Comments

SWG-2008-00497

Kenneth Teague

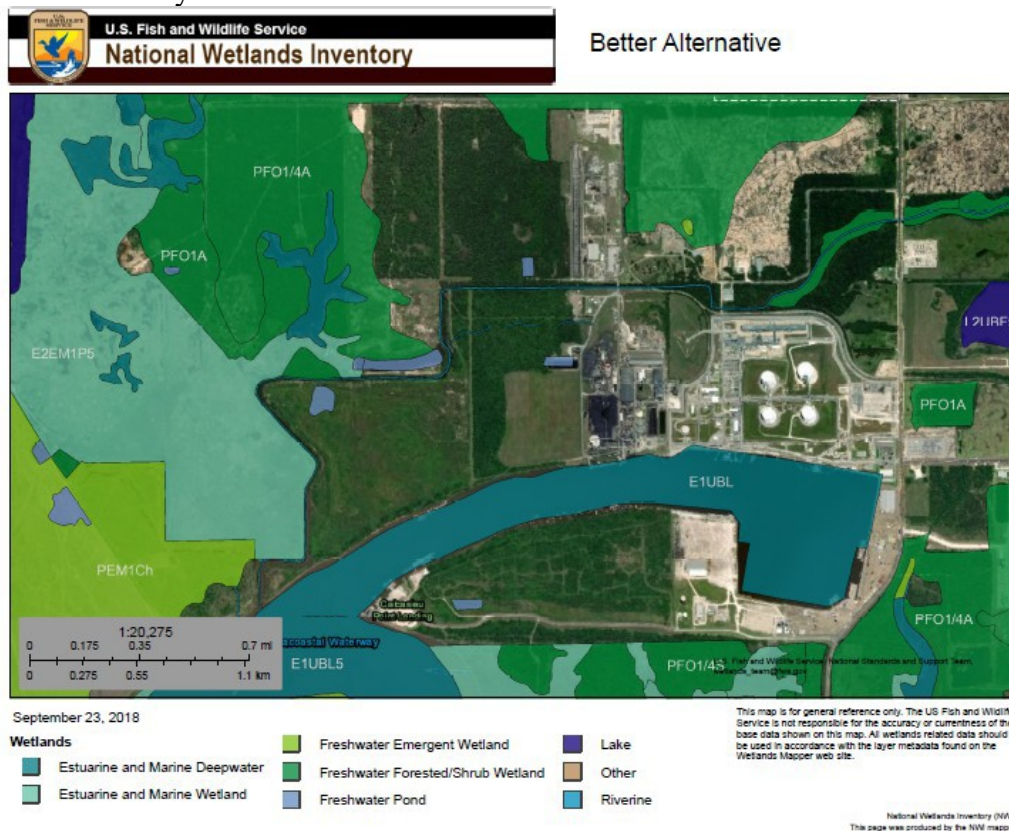
- While the PN does not include information regarding alternatives considered, the DEIS did not evaluate an obvious alternative to the proposed LNG facility, located about 45.2 mi NE of the proposed site, on the eastern side of the lower Calcasieu River in southwest Louisiana:
 - The alternative location is the undeveloped upland tract on the N side of the dredged artificial water body in the image above. It seems highly likely that this alternative would impact fewer wetlands.
